PREVOST

SAFETY RECALL

SR22-09A

DATE :	Month 2022	SECTION :	18 BODY
SUBJECT:	Passenger Seats – Center Belt Buckle Replacement

Figure 2: Remove buckle

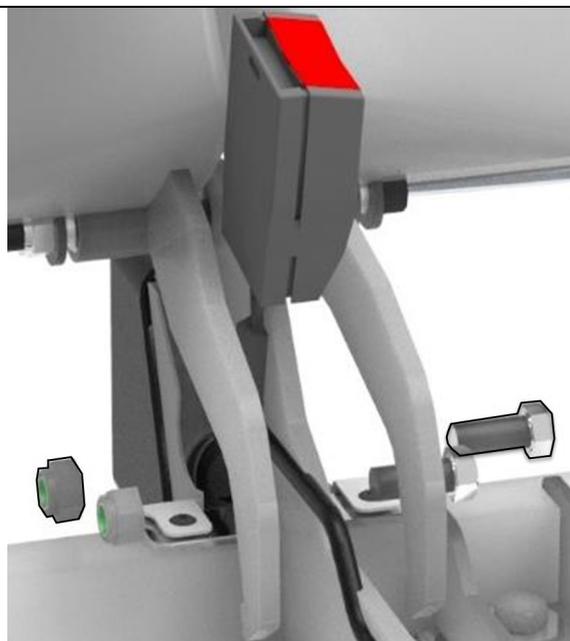
2. Recline backrest.
3. Remove *center* belt buckle by removing 7/16" screw.
4. On rear cross seat, remove buckles in all seat positions.
5. Discard buckle and hardware.

Figure 3: New buckle in top hole.

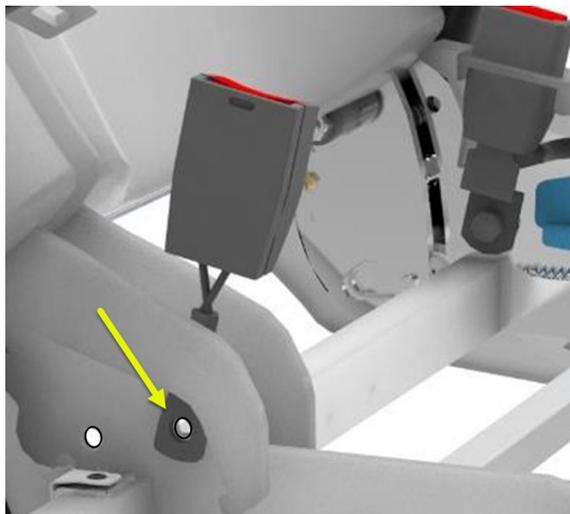
6. Install new buckle with new hardware in the **top-hole** position.
7. Tighten to **28-35 lb-pi**
8. Apply torque seal mark.

Figure 5: Center buckle access

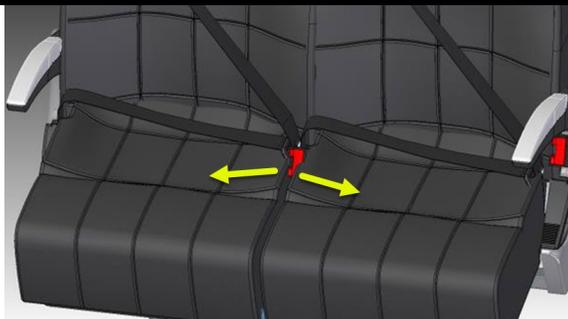
10. Access buckle mounting point by widening the cushion gap.

Figure 6: buckle removal

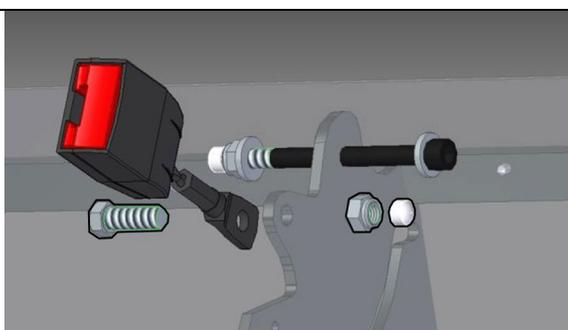
11. Remove buckle and hardware. Discard.

Figure 7: Buckle installation

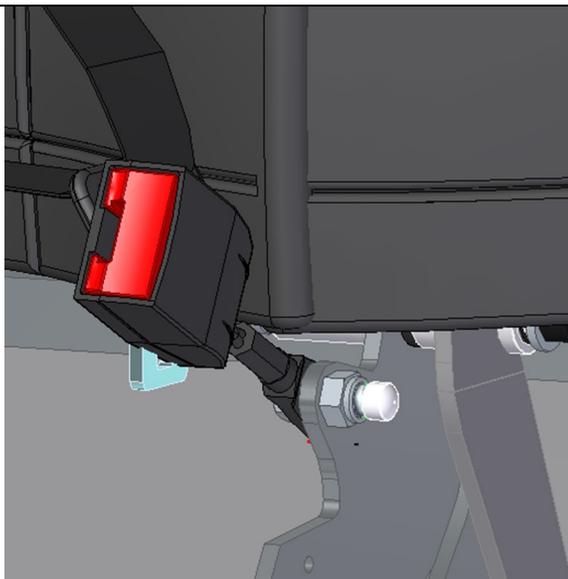
12. Install new buckle with new hardware.
13. Tighten to **28-35 lbf-pi**
14. Apply torque seal mark.
